DESIGN DS	DRAWN BY DS	DART AEROSPACE LTD VICTORIA INTERNATIONAL AIRPORT, CANADA	
CHECKED [Signature]	APPROVED [Signature]	DRAWING NO. DEO 9097	REV. A SHEET 1 OF 1
DATE 97.12.14		TITLE 204/205 SKIDTUBE DRILLING CHANGE	SCALE NTS

DART ENGINEERING ORDER

TO AMEND DWGS: D2580 REV. B
D2590 REV. B
D2596 REV. B
D2597 REV. C

HOLE PATTERN FOR 204/205 SKIDTUBES SHOULD BE ADJUSTED
AS FOLLOWS:

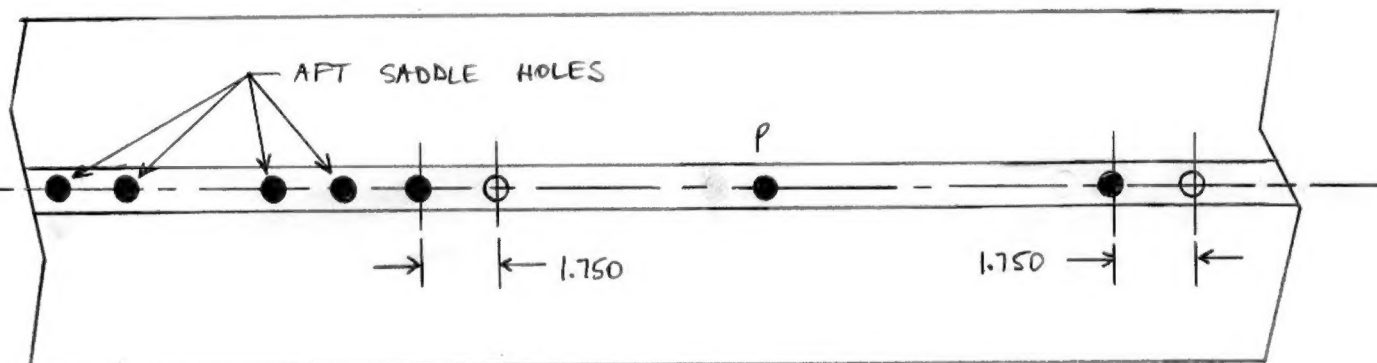
NOTE: 1. ● = EXISTING HOLE
○ = NEW HOLE

2. WEB HOLES SHOULD BE DRILLED TO $\phi 0.63$ AS PER DWGS D2596 / D2597 (OPEN TO 0.500 IF ASSEMBLED TUBE IS BEING MODIFIED)
3. SKIDTUBE HOLES SHOULD BE DRILLED TO $\phi 0.500$ AND D2579 SPACERS SHOULD BE INSTALLED PER DWGS D2580 / D2590.
4. D2594 PLUGS SHOULD NOW BE INSTALLED IN HOLE MARKED 'P' ABOVE (TOTAL NUMBER OF PLUGS INCREASED FROM 14 TO 16)
